DIST	COUNTY	ROUTE	KILOMETER POST TOTAL PROJECT	SHEET No	TOTAL SHEETS
04	SF	80	13.2/13.9	103 S2R3	1204

MARK	DATE	DESCRIPTIONS	BY	CH'D	CCO#
3	02/17/12	CABLE TRAY COVER AT W2	RSB	RG	234
2	03/01/11	BASE INTEGRATION	RSB	WB	150
1	11/20/09	ELECTRICAL GROUNDING	RR AWG	RG FW	75
0	02/25/08	CABLE TRAY CHANGES	TW	RG SE	42S1

DETAILS
UNDERGROUND
PIER W2W PLANS AND SECTIONS
SCALE AS NOTED

E-20B

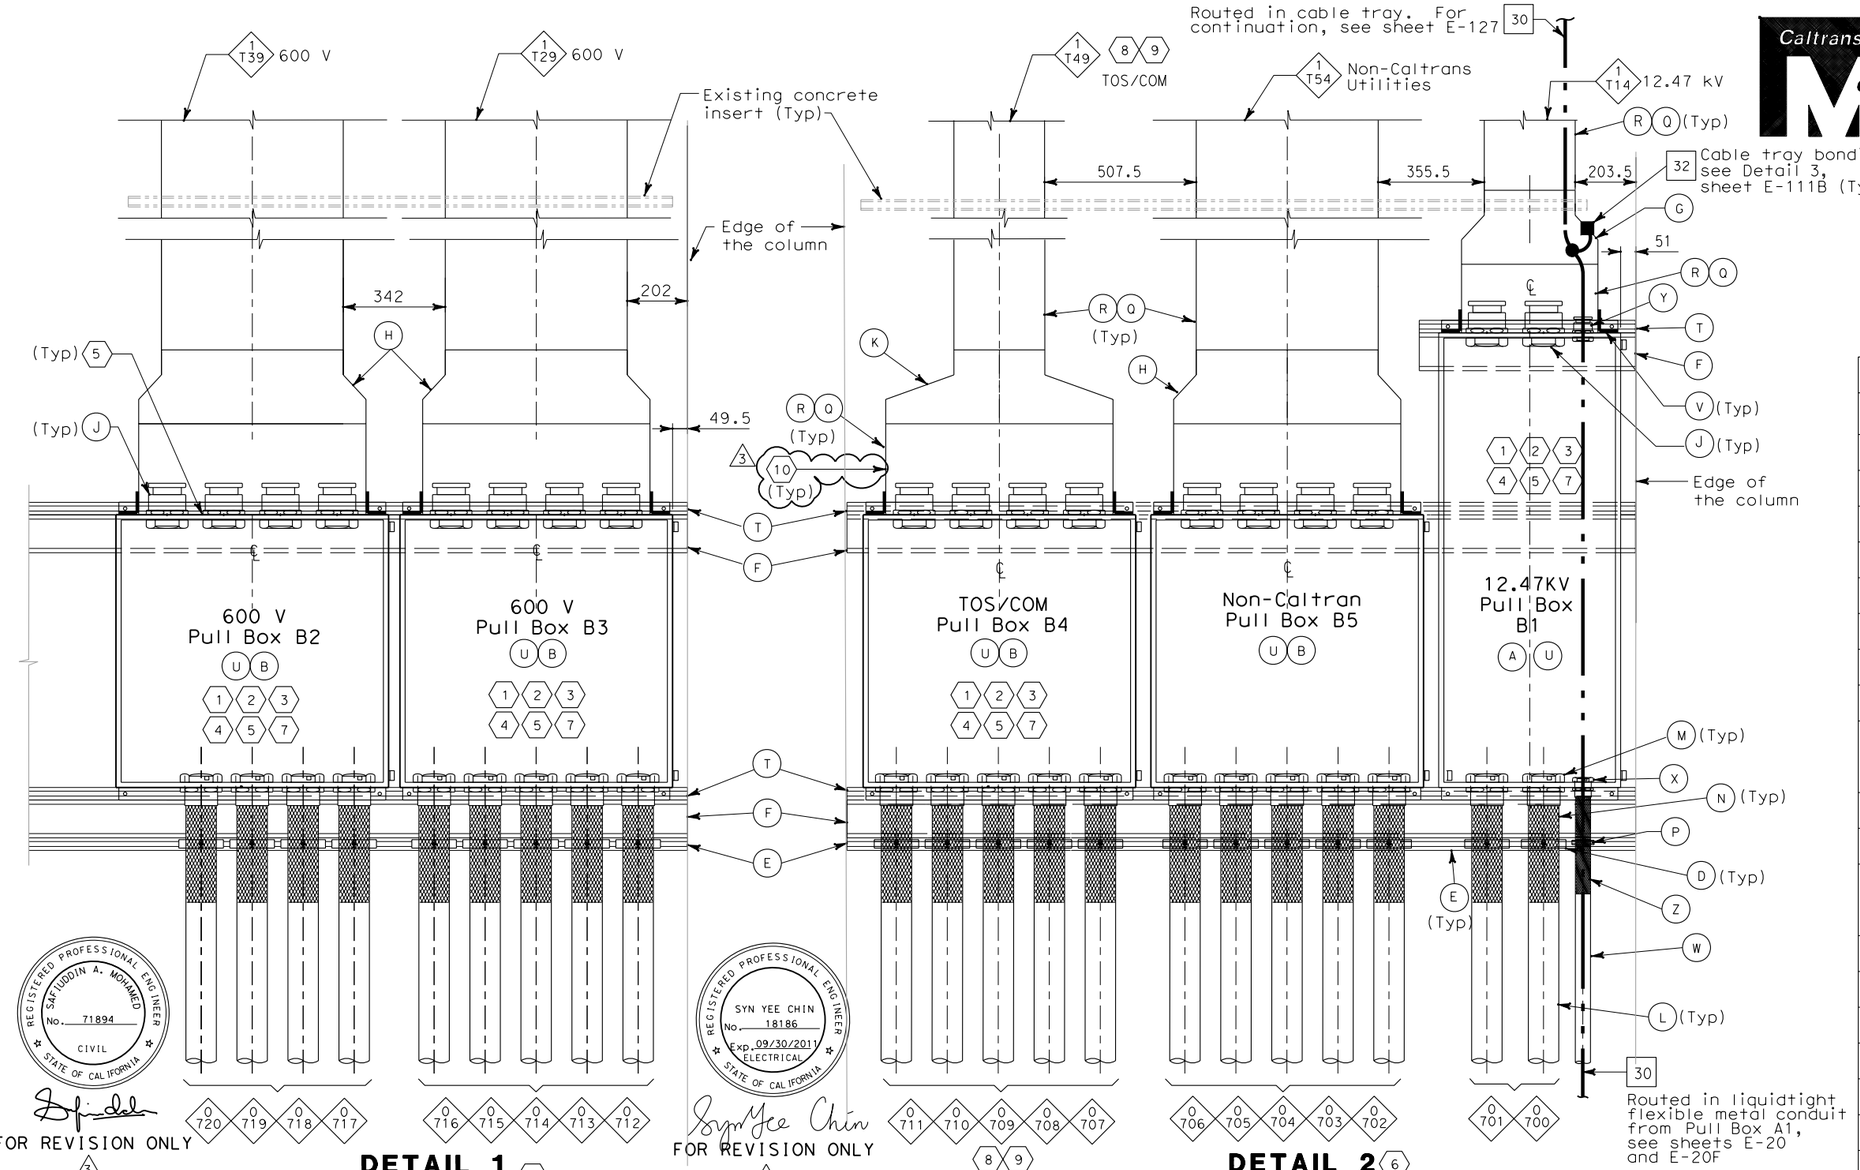
10. For vertical cable tray not flush with the pier column wall, Contractor shall provide solid flanged cover on top and bottom of cable tray with approved heavy duty cover clamps. (3)
